Development Review Committee (DRC) Meeting

Tuesday, July 6th, 2023 – 9:30 AM

1. CALL TO ORDER
2. ROLL CALL
3. APPROVAL OF MINUTES
 - DRC meeting on June 20th, 2023
4. NEW BUSINESS
 - **Case # 22-01-PUD-Riverview Estates**; *Second Review*, Applicant is requesting approval of a Zoning Map amendment from Rural Agriculture (A-2) to Residential Planned Unit Development (RPUD) at the property addressed as 181 Fort Florida Road for the development of a single-family detached neighborhood of up to 91 units.
 - **Case # 23-01-MAJPUD-Saxon Pointe Amendment 2**; *First Review*, Applicant is requesting approval of a major PUD amendment for the Saxon Pointe PUD located on the southeast corner of U.S. Highway 17/92 and Saxon Boulevard to allow for a convenience store with or without fuel dispensers, restaurants, and self-storage.
5. ADDITIONAL BUSINESS:
6. DISCUSSION:
7. ADJOURNMENT:

**City of DeBary
Development Review Committee Meeting
June 20, 2023 - MINUTES**

EXHIBIT "B" MASTER DEVELOPMENT PLAN

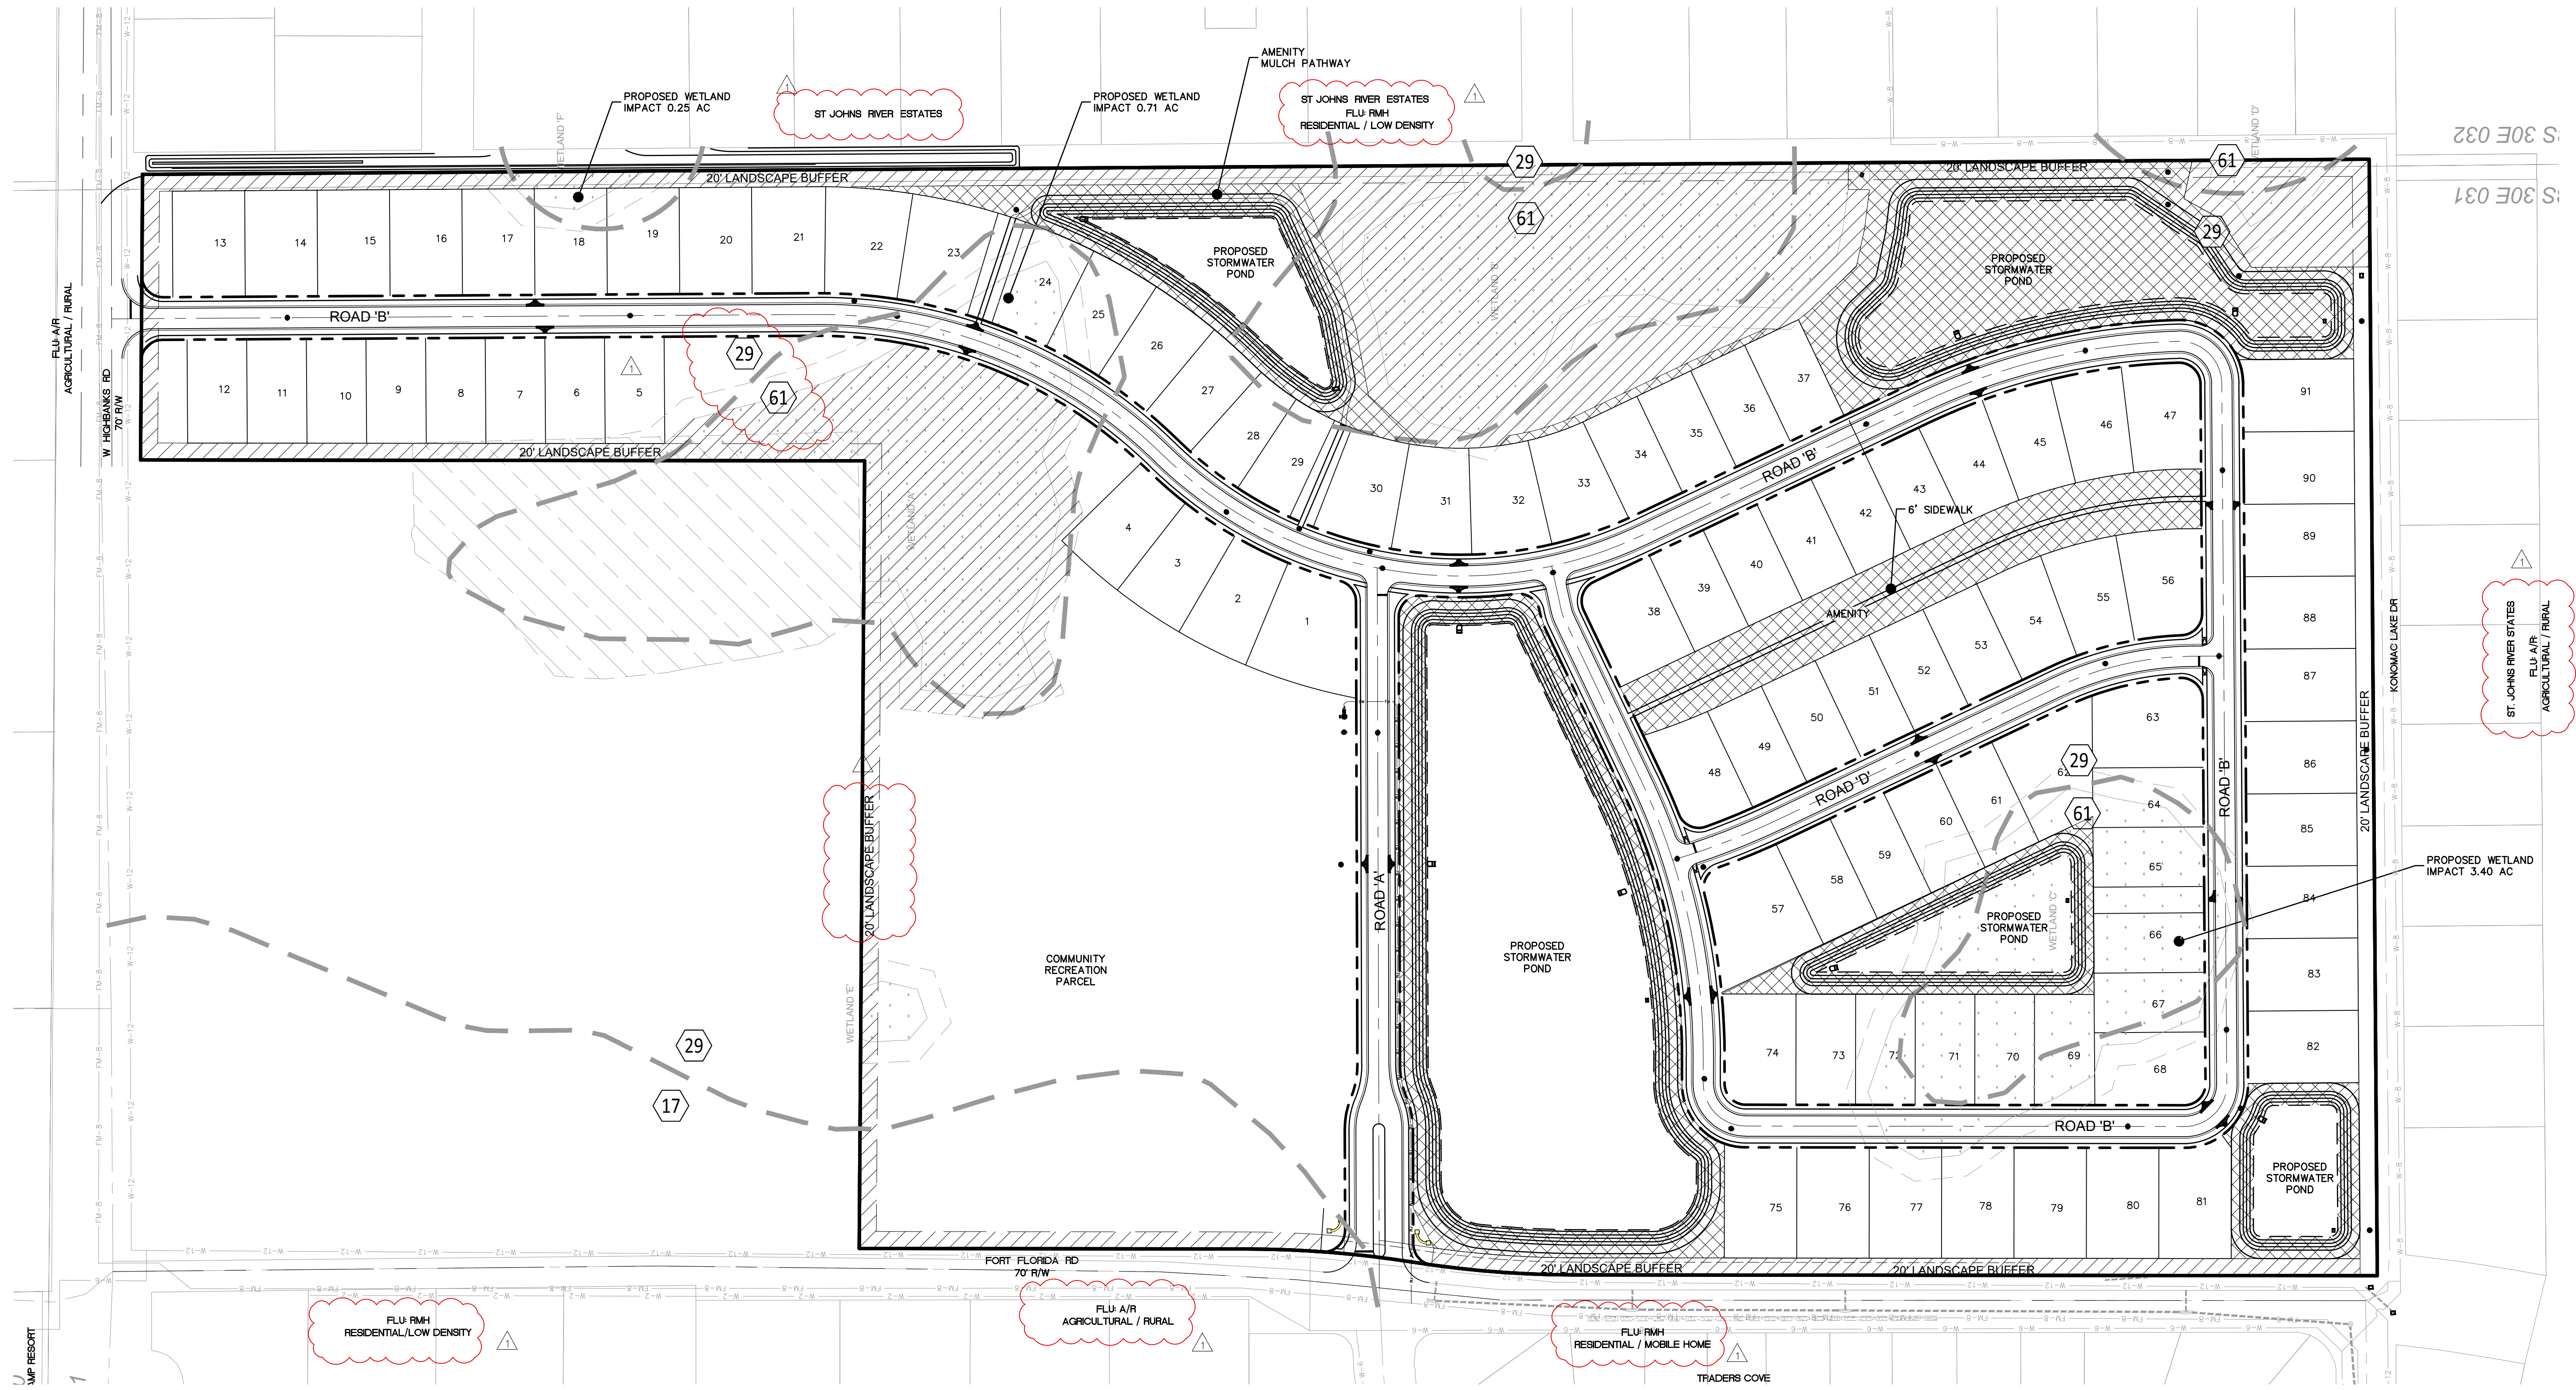
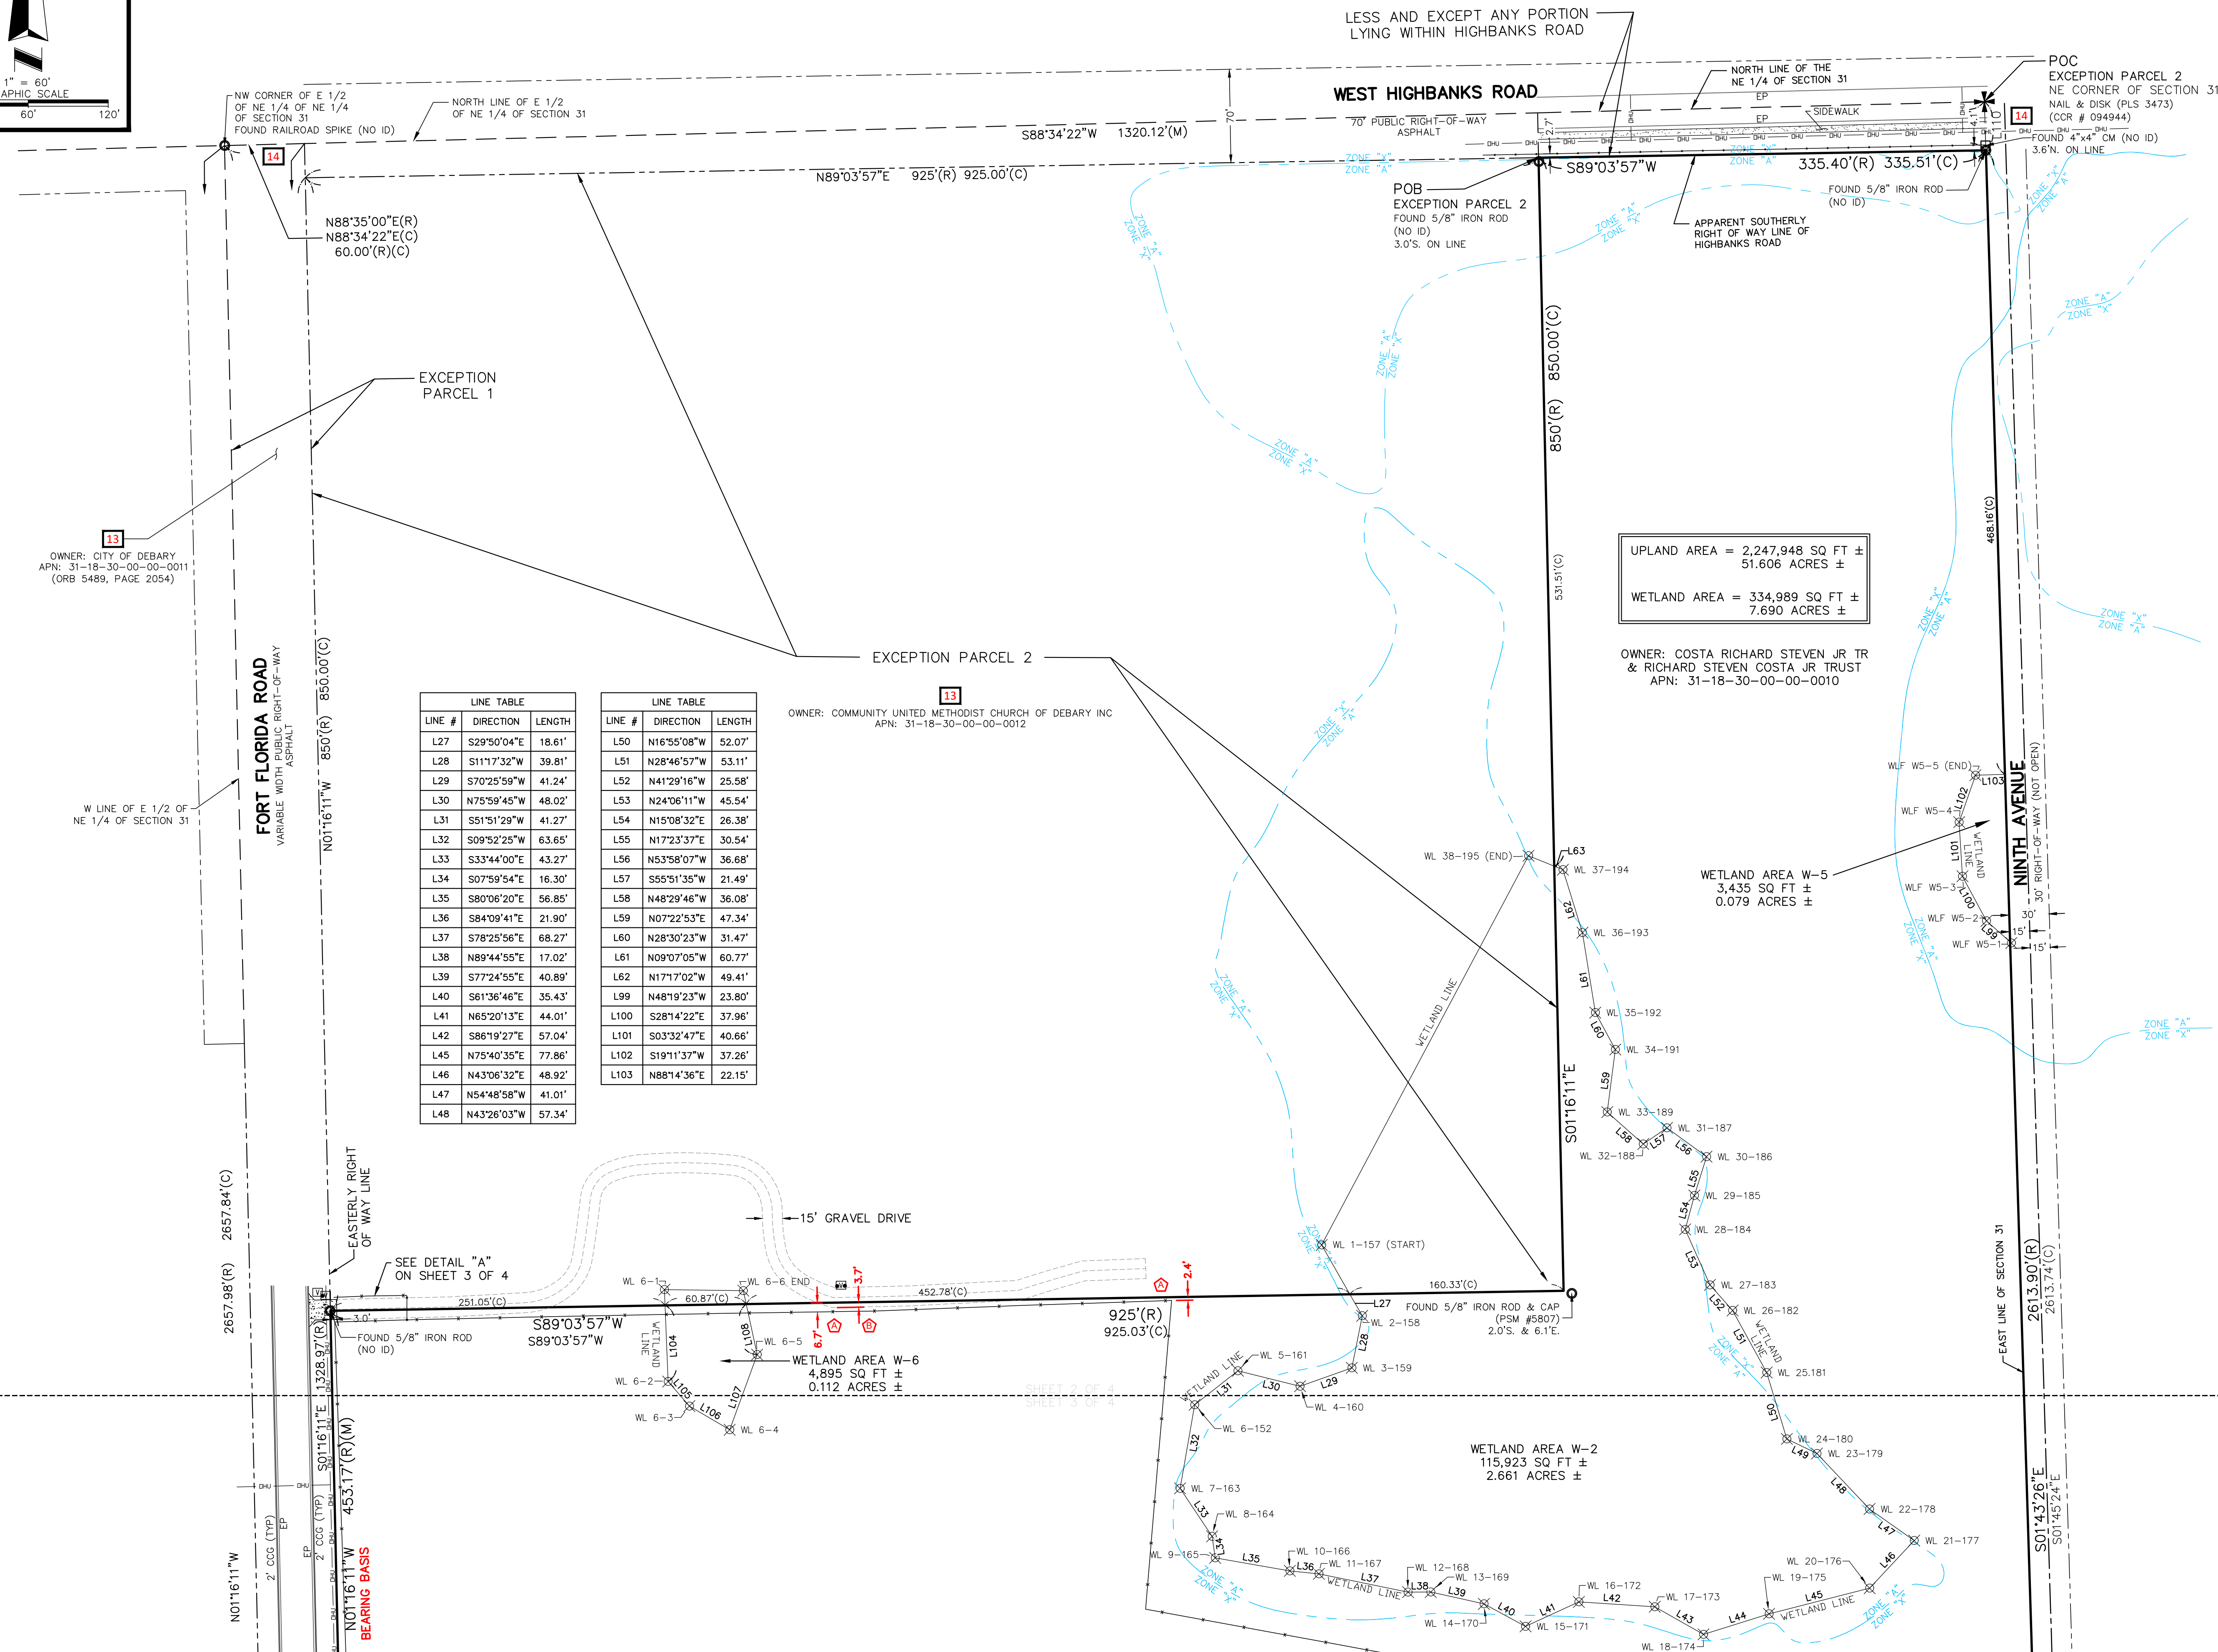
The MDP needs to show the proposed RV and boat storage spaces – I did not see that on the current plan.

2. On the site plan, the gross and net density state 93 DU (dwelling units) instead of the 89 DU analyzed. Please clarify.
3. Use the updated FDOT count data for Site 8004 to include year 2022. Please update the analysis based on these changes.
4. Appendix, TIA Exemption Memorandum, for the driveway intersection analysis, were existing traffic on Highbanks Road collected or derived?

6Dvii ALTA/NSPS LAND TITLE SURVEY
 2
 BOUNDARY SURVEY OF
 FORT FLORIDA
 SECTION 31, TOWNSHIP 18 SOUTH, RANGE 30 EAST
 VOLUSIA COUNTY
 DEBARY, FLORIDA

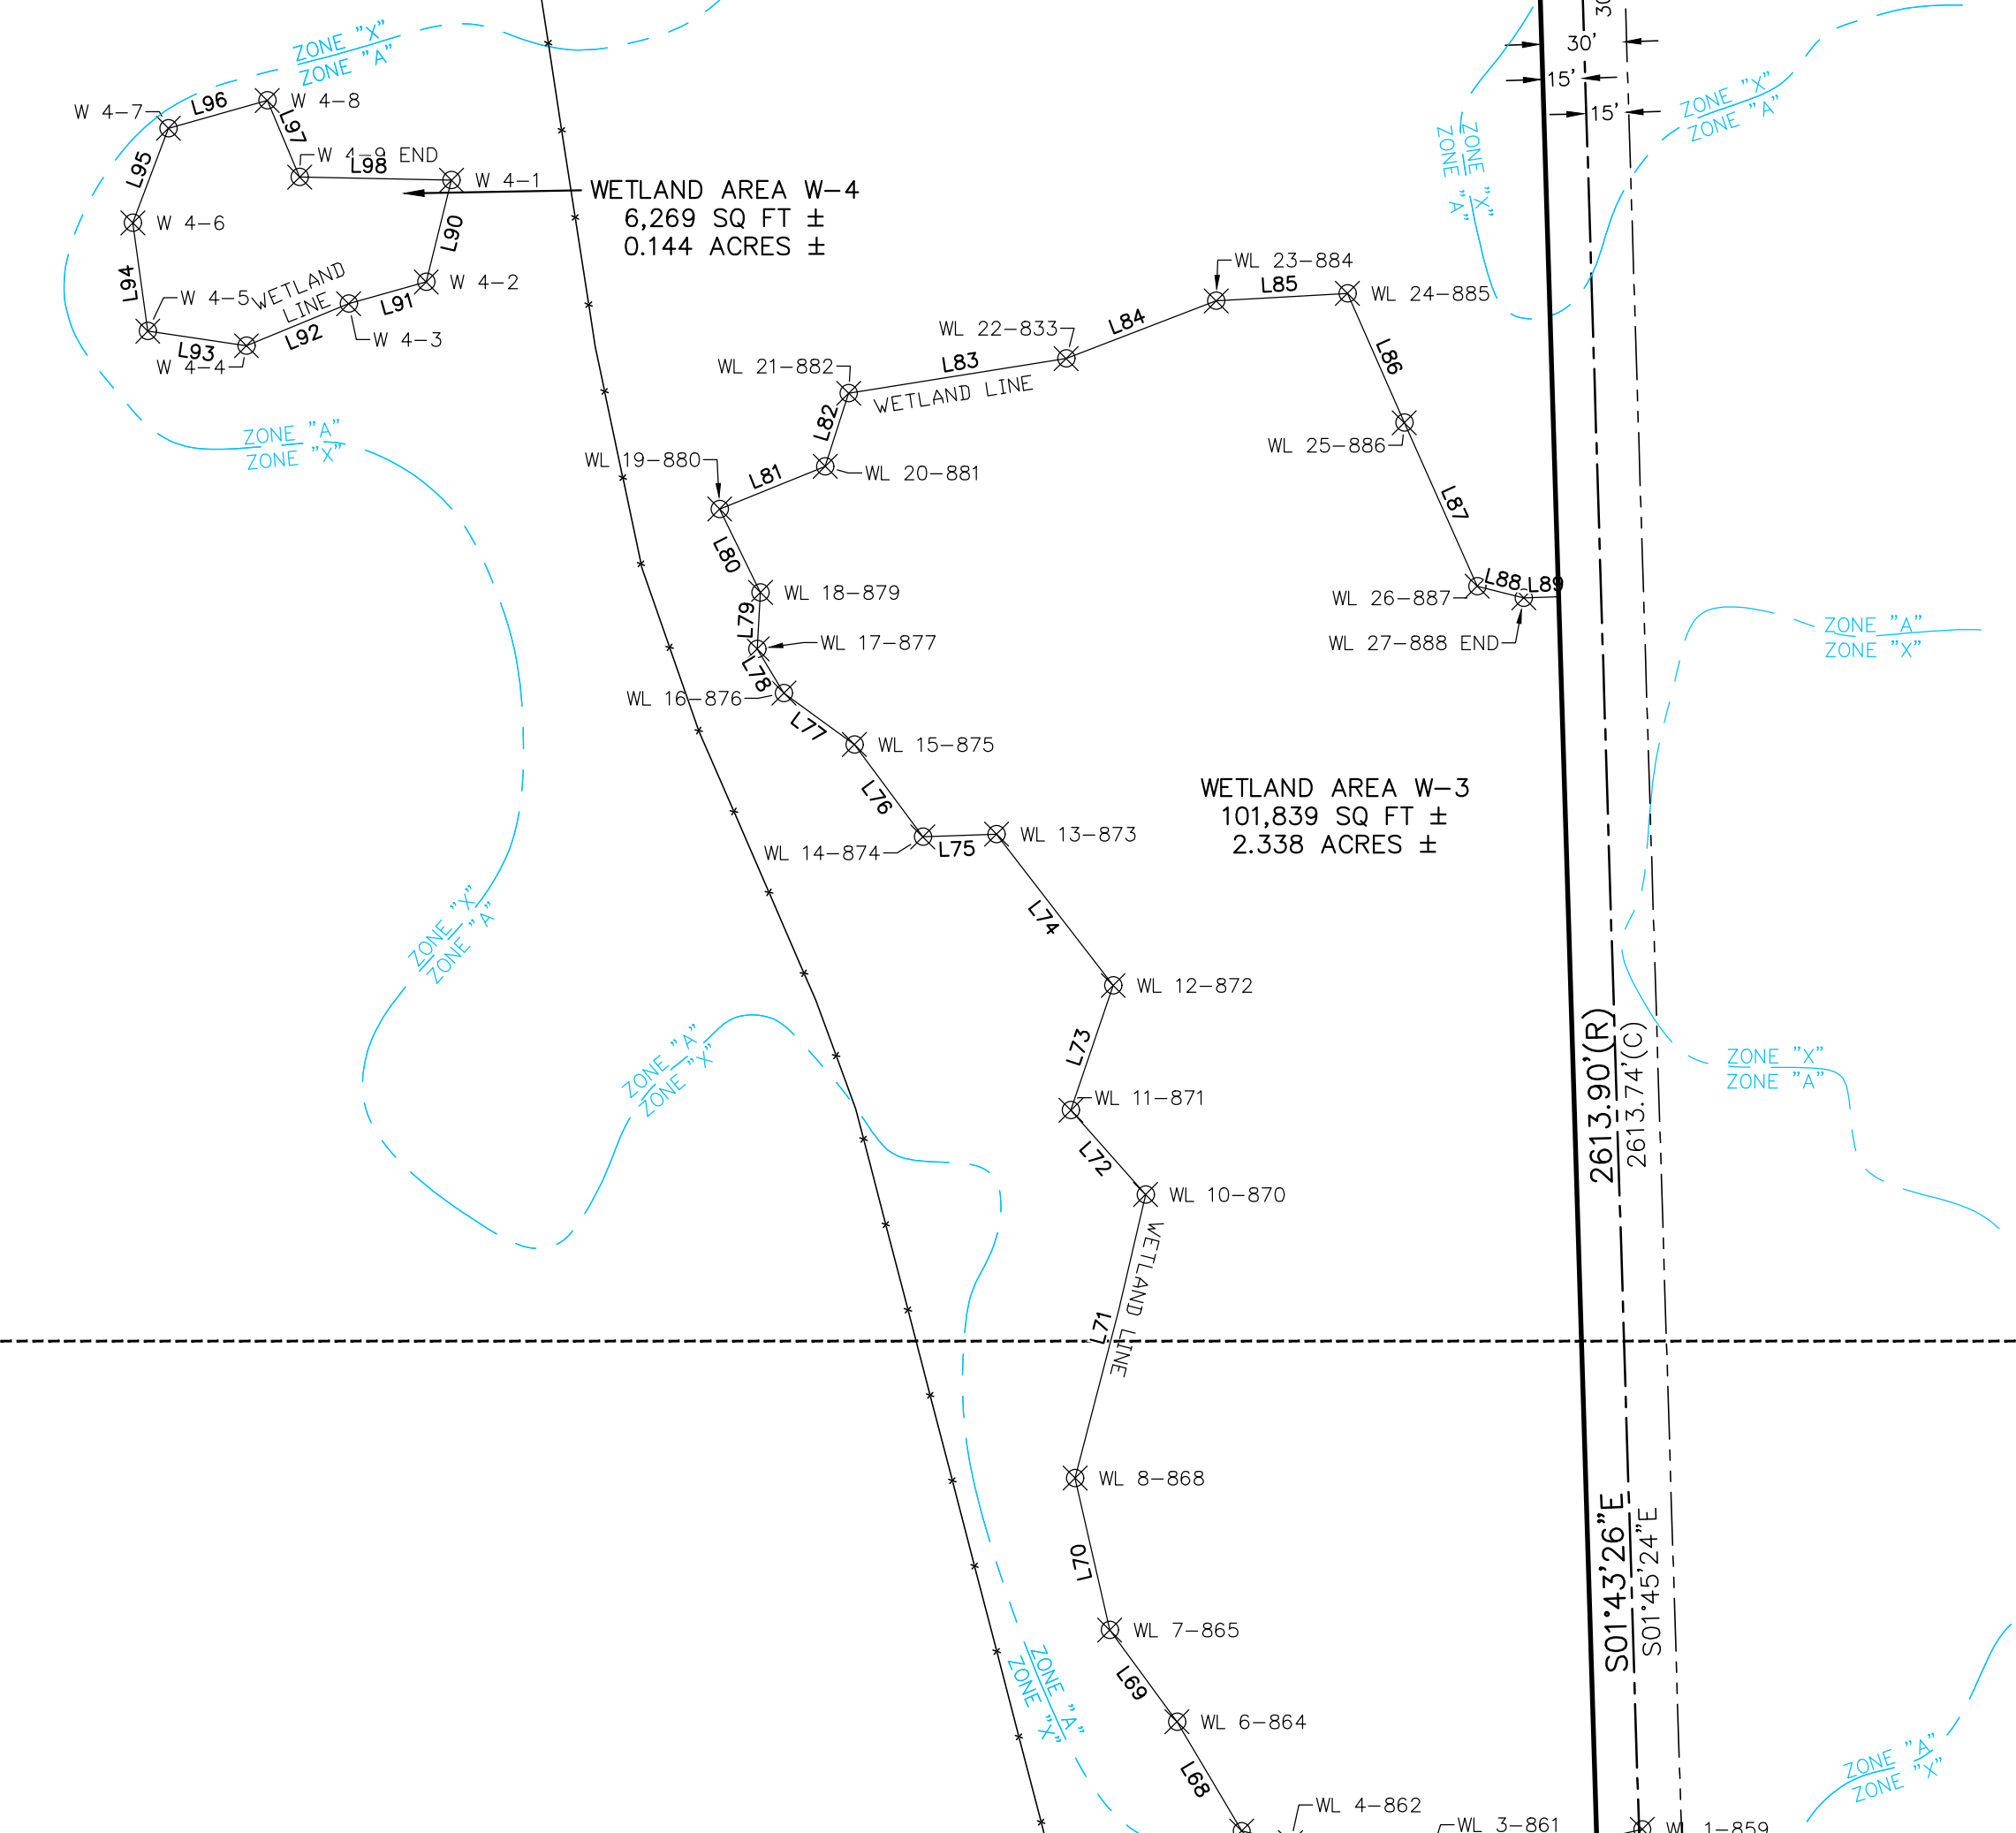
6. Sheet 2: Revise description of the NW Corner. "should read "NW corner of the E 1/2...."

a. Sheet 2: North Line should read: NORTH LINE OF THE EAST 1/2 OF THE NORTHEAST 1/4 OF SECTION 31 per legal description.

7. Sheet 2: Overlapping leaders overlapping L110

8. Sheet 2: Bearings and distances on the same level can be confusing, may consider using different levels of placement and separate arrows. For example the Boundary line defined by S 01°16'11"E with distances of 531.51(C), 850(R), 850.00(C).

9. Sheet 2: Add leaders.

10. Sheet 2: Cropped Text due to XRef
